**Appendix I – Response to Comments on the 90% Design Documents (Basis of Design Report, O&M Manual, Construction/Remedial Action Work Plan)**

Groundwater Remedy Basis of Design Report/Final (100%) Design

PG&amp;E Topock Compressor Station, Needles, California

TOPOCK GROUNDWATER REMEDIATION PROJECT  
BATCAVE WASH-  
PLAN AND PROFILE - PIPELINE "I"  
STA 16+00 TO STA 22+09  
GAS TRANSMISSION & DISTRIBUTION  
PACIFIC GAS AND ELECTRIC COMPANY  
SAN FRANCISCO, CALIFORNIA

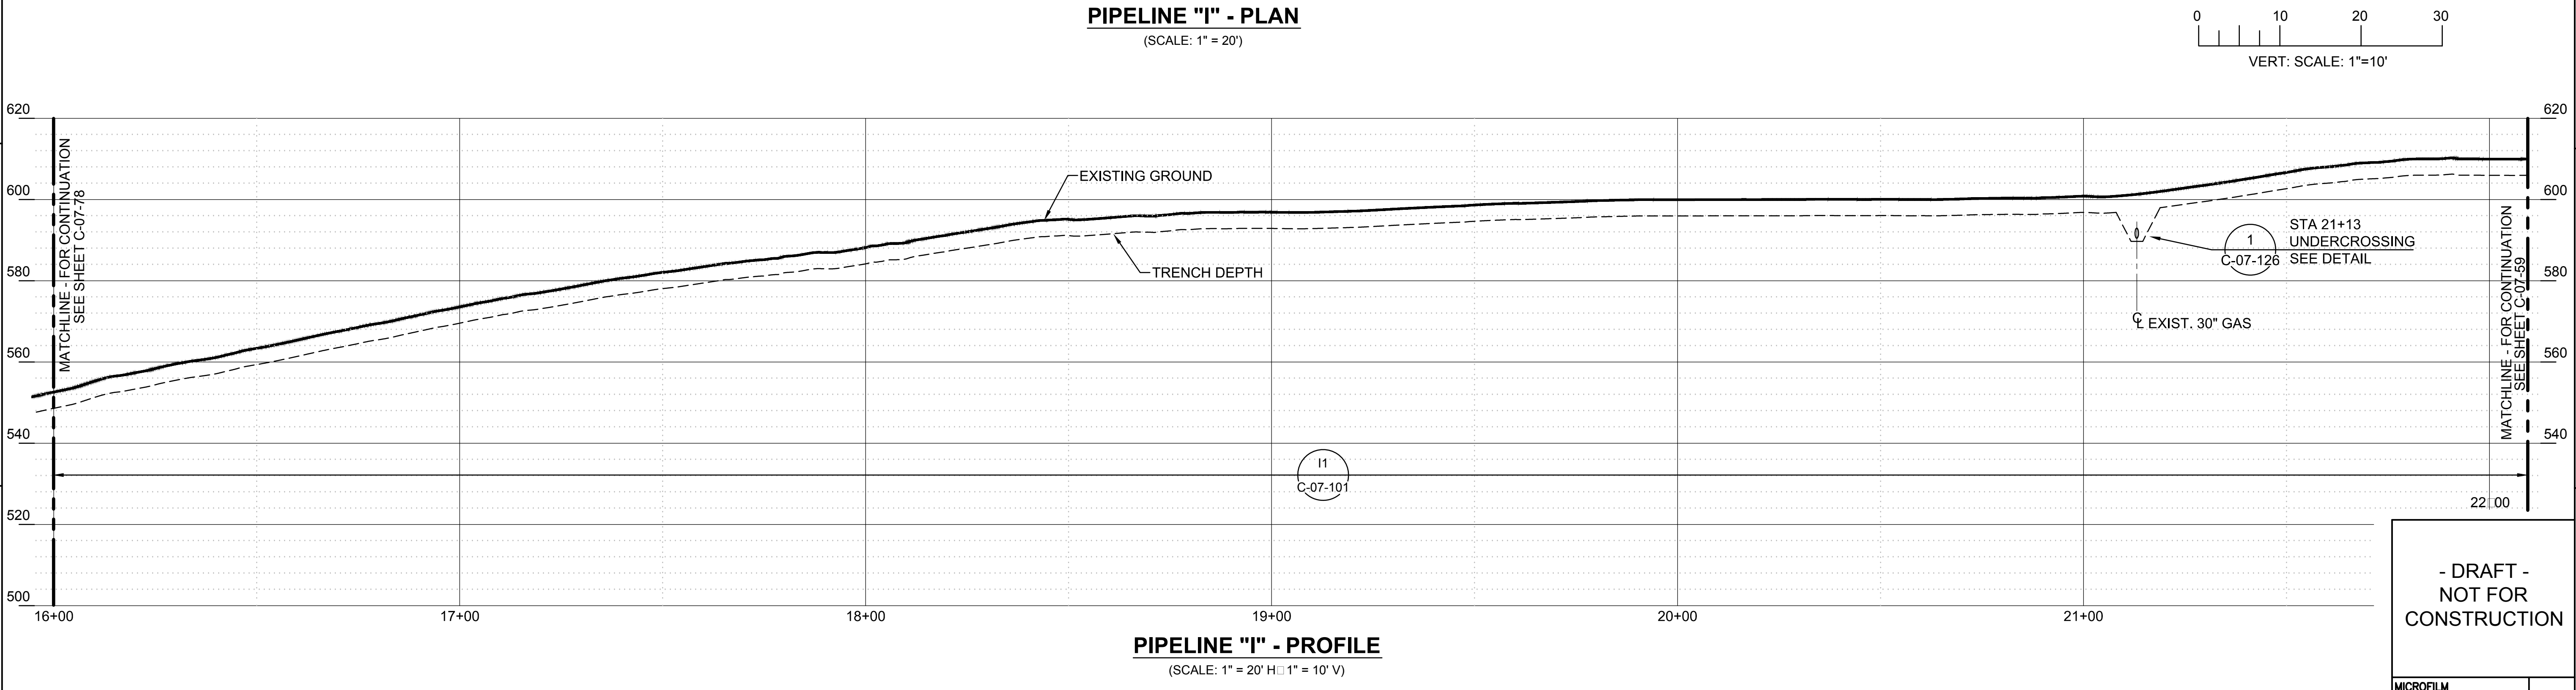
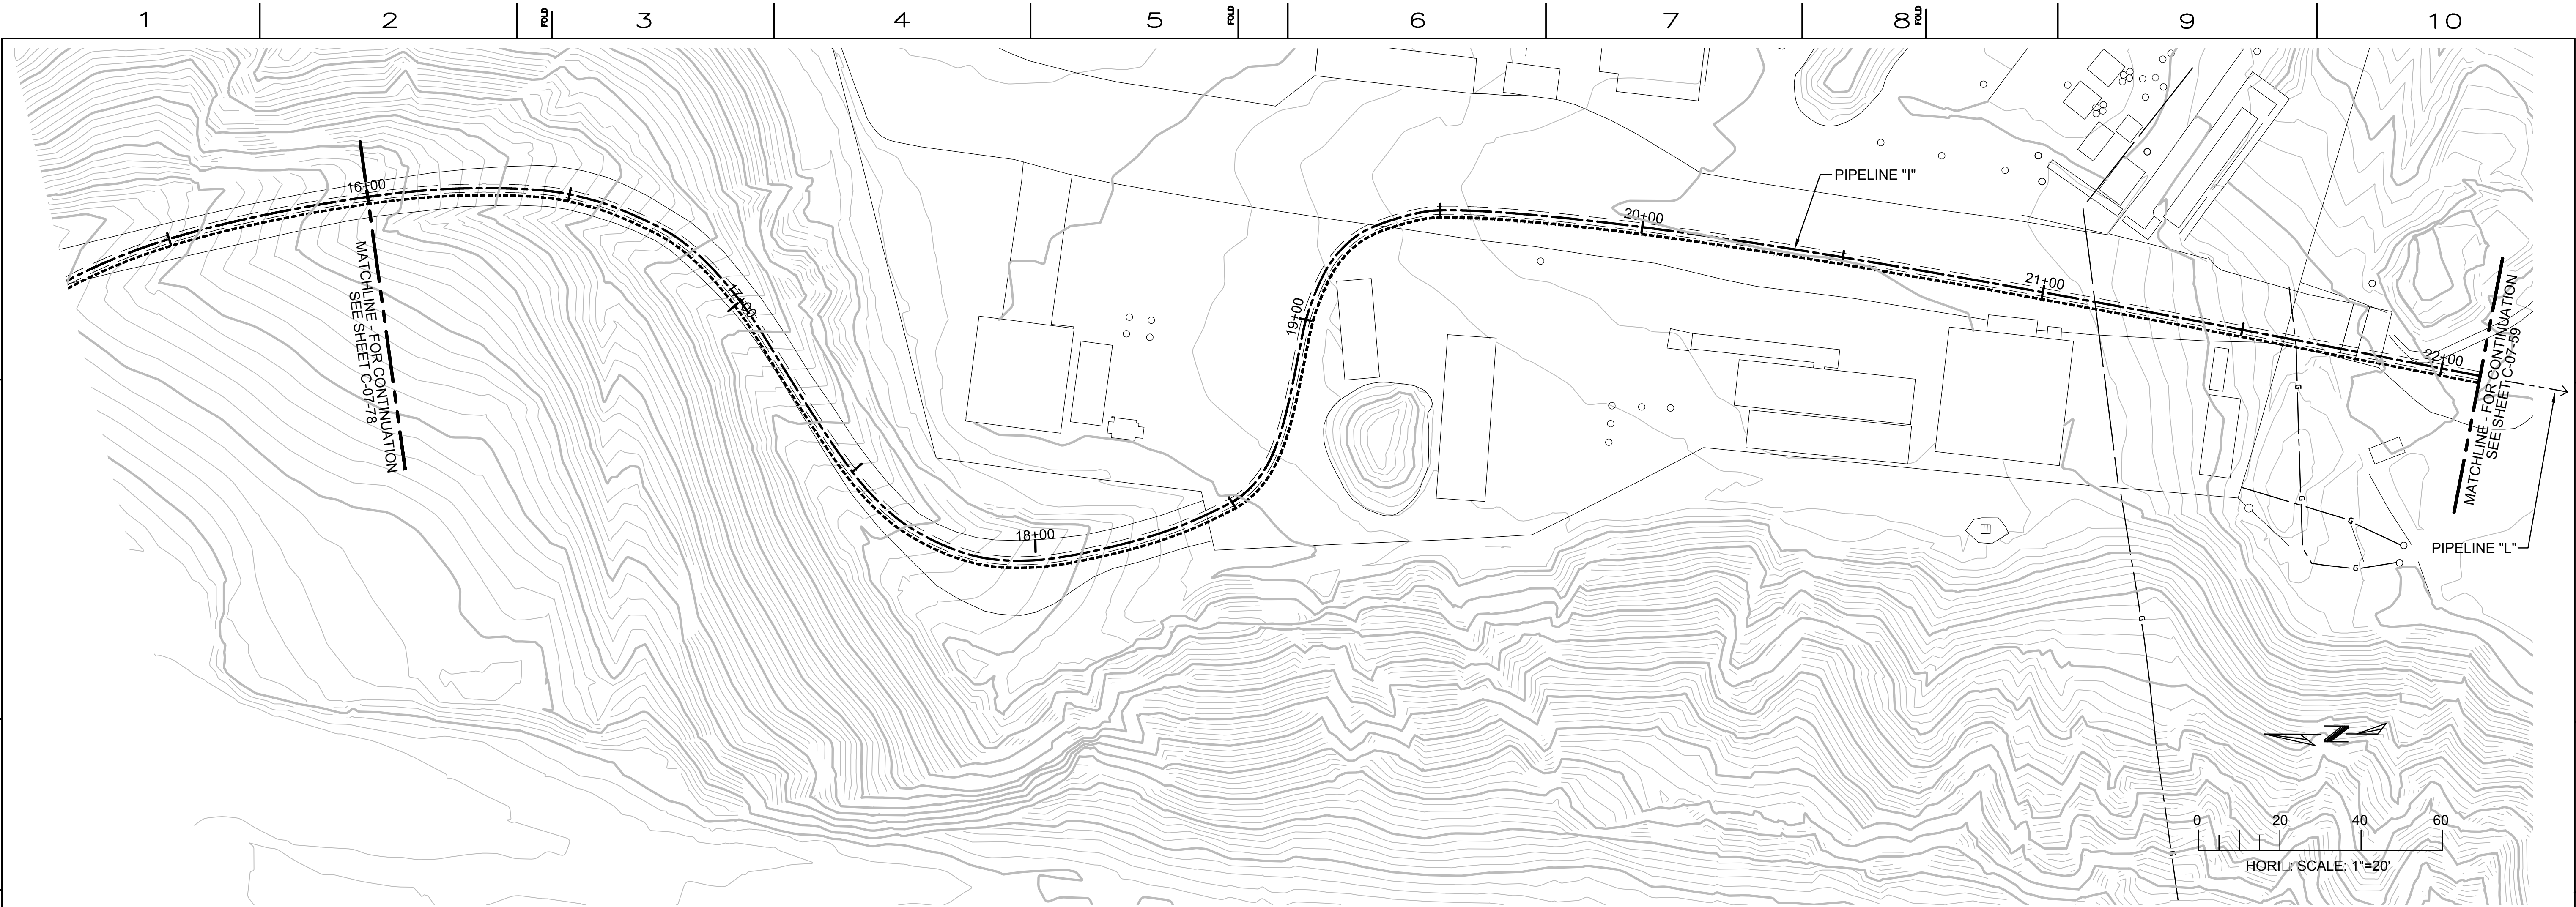
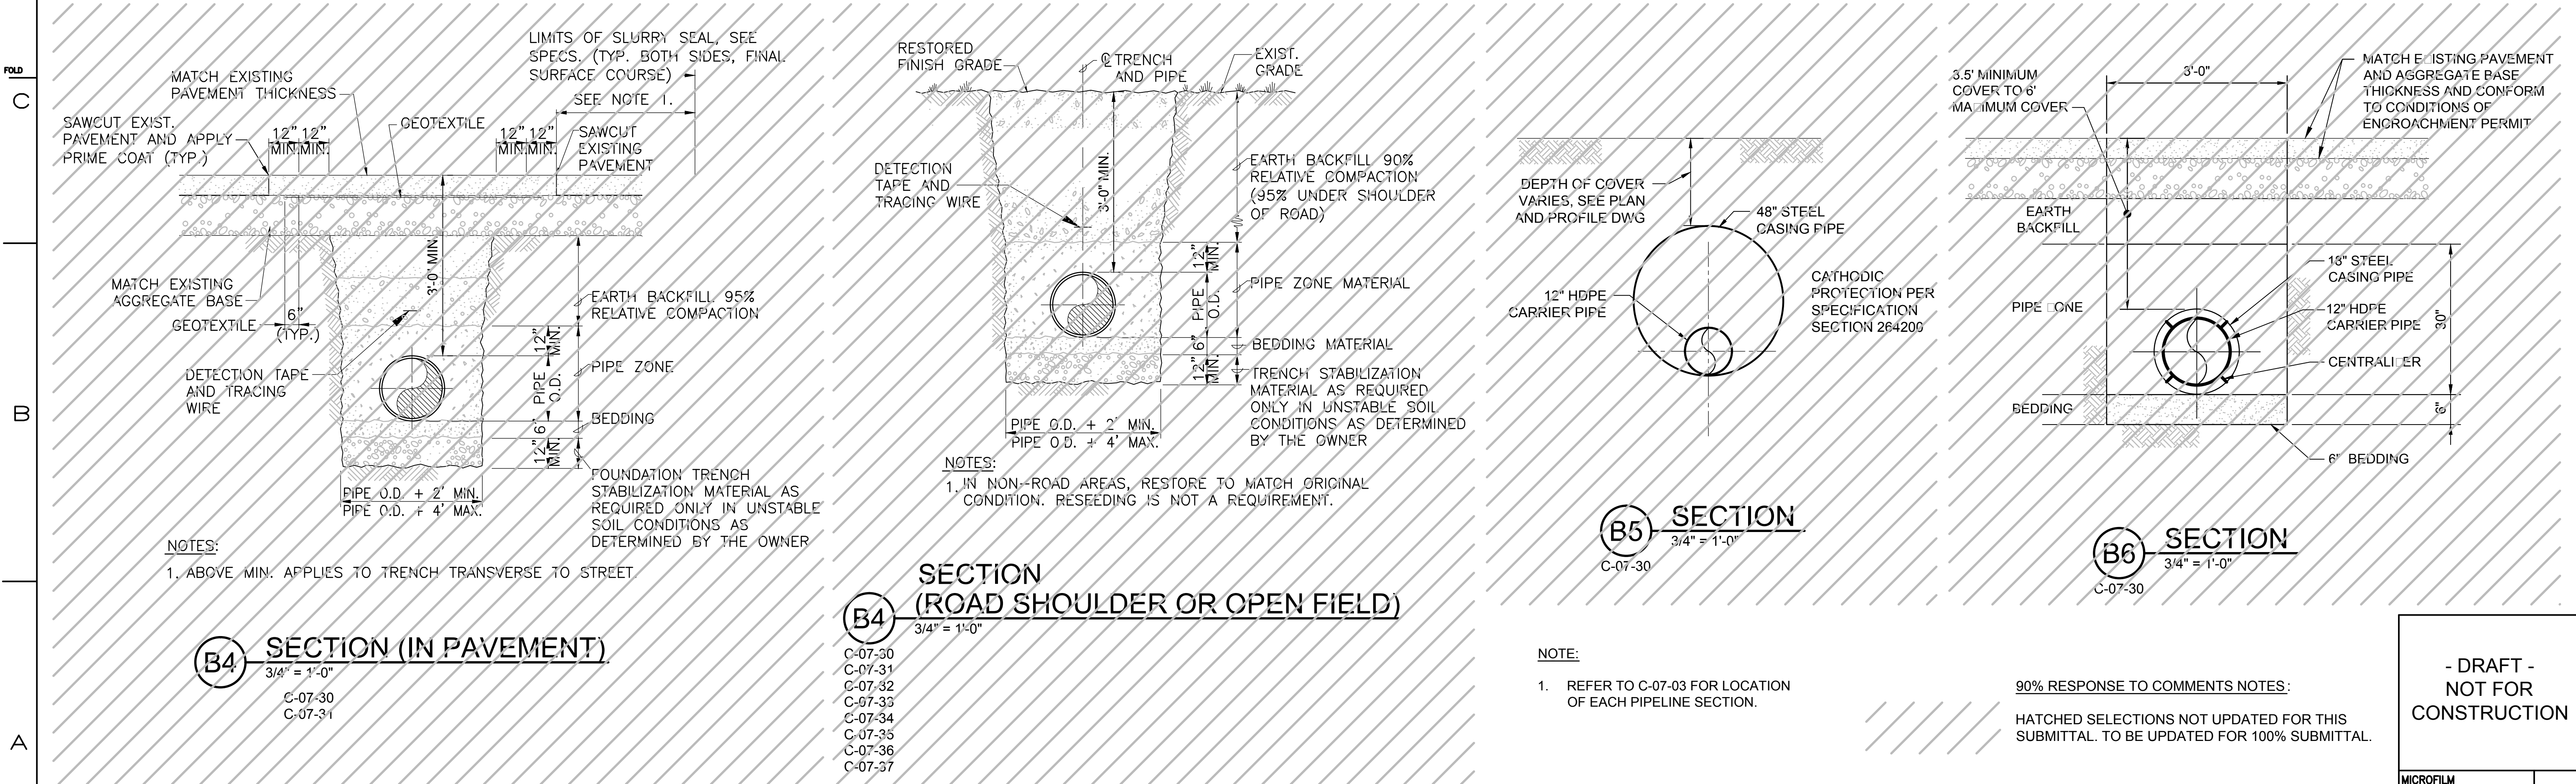
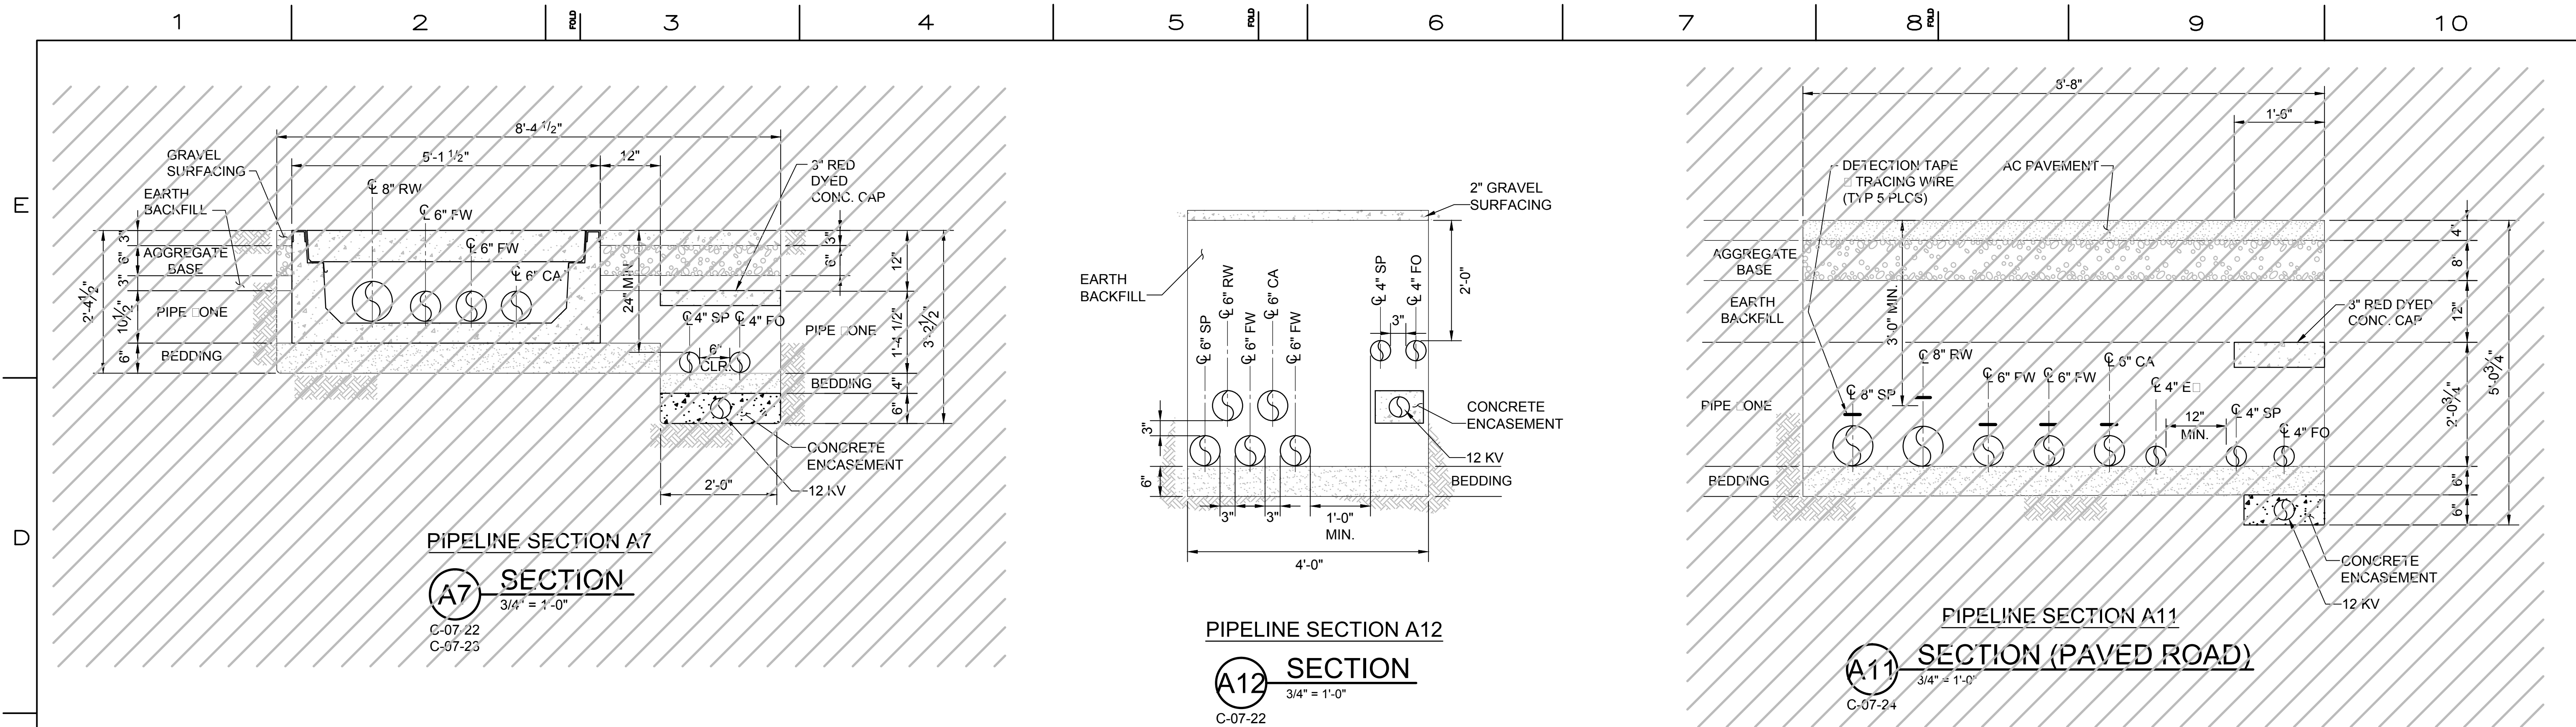
548	JDS	Design	Remedial Design	Appendix D: Figure C-07-23		Provide spec for vertical separation between existing IM-3 piping and full-scale pipe and conduit. Horizontal spacing provided in the notes but not the vertical spacing.	Specifying the vertical separation of IM-3 and remedy piping is not necessary except in the locations where the pipes cross. Remedy pipelines and trenches are to be installed at the depths shown, where ever piping crosses; vertical distances between the piping will be included in the final design drawings.			Noted.	
549	FMIT	Design	Infrastructures	Appendix D; C-07-100, C-07-101, C-07-102, C-07-103	CH2MHILL 90% Design Plans	<p>There appears to be an inconsistent application of the pipe and conduit spacing in the pipe cross sections from the engineering specification. This inconsistent spacing typically results in a wider trench than appears to be necessary. Trench width may be reduced if minimum design spacing of 3-inches between water pipes or sum of half the diameters for pipelines or electrical conduit are used, in some cases up to 1 foot may be eliminated. Optimizing the trenches may result in significant reduction in the volume of excavated materials.</p> <p>Details A2 and A5 have concrete encasement width of 2-feet, while A6 has a 1'-6" encasement. Concrete encasement for 12 kV line varies from 1'-6" to 2'-9". Varying red concrete cap widths, some details cover all electrical conduits, while others do not. Detail A3 has electrical conduits within the 12 inch min. spacing, not protected by a concrete cap, or detection tape. Why is there a 12" min between concrete trench and electrical conduit?</p> <p>Multiple details show a 12" minimum spacing between water pipes, concrete, and various objects (i.e. concrete, electrical pipes, concrete trench for example). Spacing between water lines inconsistent, for example Section H1 depicts 9-inches of spacing between water lines, while Section A10 spacing ranges between 4 and 6 inches between water lines. Narrower trenches are preferred by FMIT.</p> <p>Spacing between conduits should be reexamined for example in Section A8 the space between 2-inch conduits is 6 inches, while in other sections the spacing is 3 inches. A final example is the width of Section H2 is narrower than Section H1. These trenches should contain the same water lines and conduits but vary in width. It should be noted that Section H1, a</p>	See RTC #21 FMIT-7.			Noted.
